SINGAPORE CIVIL DEFENCE FORCE

Our Ref: CD/04/05/01/01

Date : 2 Sep 2024

AMENDMENTS TO FIRE CODE 2023 – 2nd BATCH OF AMENDMENTS

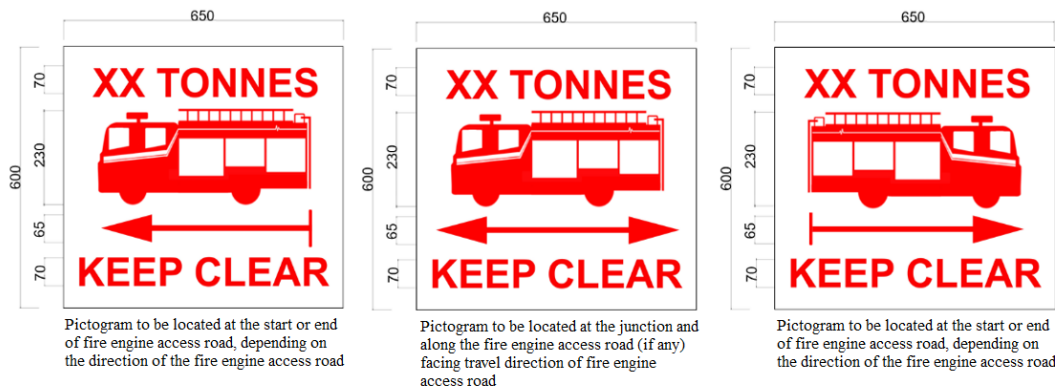
<p>vertically, or adjacent to or facing it.</p> <p>c. Underground installations</p> <p>(1) BSS is allowed to be located within basement car parks protected by mechanical ventilation in accordance with <i>Cl.6.4.5</i> and automatic sprinkler system in accordance with <i>Cl.6.4.1d.</i></p> <p>(2) The maximum allowable depth shall not exceed 9m below the average grade level, and not more than one level below grade level.</p> <p>d. Aggregate stored energy capacity</p> <p>(1) Aboveground installations</p> <p>Aggregate stored energy capacity of each BSS unit shall not exceed 20kWh. Where more than 1 BSS unit is installed, a minimum separation distance of 3m between BSS units shall be provided and the total aggregate stored energy capacity of all BSS units shall not exceed 100kWh.</p> <p>(2) Underground installations</p> <p>Aggregate stored energy capacity of BSS within basement car parks shall not exceed 10kWh.</p>

<p>e. Fire safety requirements</p> <p>(1) BSS units shall be located at least 6m away from the nearest edge of exit staircase/ fire lift lobby/ smoke-free lobby.</p> <p>(2) BSS units shall be located at least 1m away from:</p> <p>(a) Non-essential equipment rooms; and</p> <p>(b) Parking lots (excluding the lots used for swapping of batteries).</p> <p>(3) Approved types of fire extinguishers of at least 2 numbers of 55A shall be provided.</p> <p>(4) Emergency isolation shut-off switch shall be provided at each BSS unit.</p> <p>(5) BSS installation at petrol service stations shall comply with specifications stipulated under <i>Cl.9.6.2v.(3)</i>.</p>
24	2 Sep 2024	2 Sep 2024	Clarification	<p>10.4 ELECTRIC VEHICLE (EV) CHARGING INSTALLATION</p> <p>10.4.1 General</p> <p>The requirements in <i>Cl.10.4.2</i> are exempted for PG I buildings.</p>	<p>10.4 ELECTRIC VEHICLE (EV) CHARGING INSTALLATION</p> <p>10.4.1 General</p> <p>The requirements in <i>Cl.10.4.2</i> are exempted for PG I buildings.</p>

Diagram 4.2.2i.(3): Pictogram signage for fire engine accessway/ fire engine access road

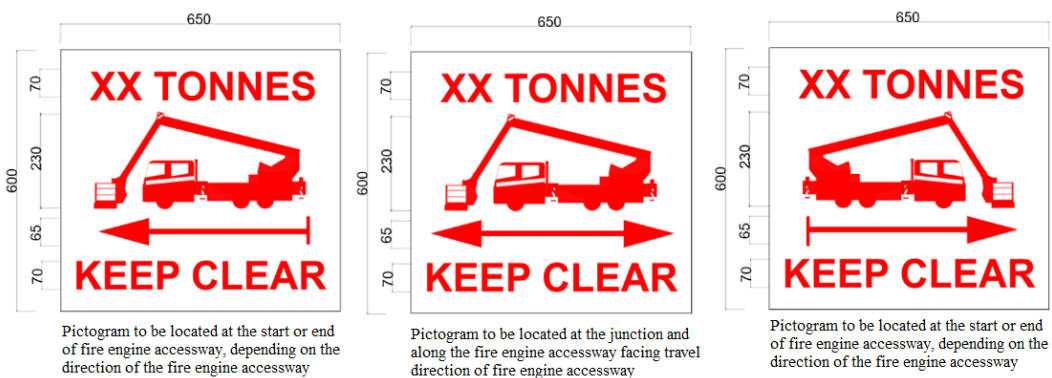
Pictogram of fire engine access road for firefighting appliance equal or more than 24 tonnes but less than 30 tonnes

Pictogram of fire engine access road for firefighting appliance equal or more than 30 tonnes

Pictogram of fire engine accessway appliance for firefighting appliance equal or more than 30 tonnes
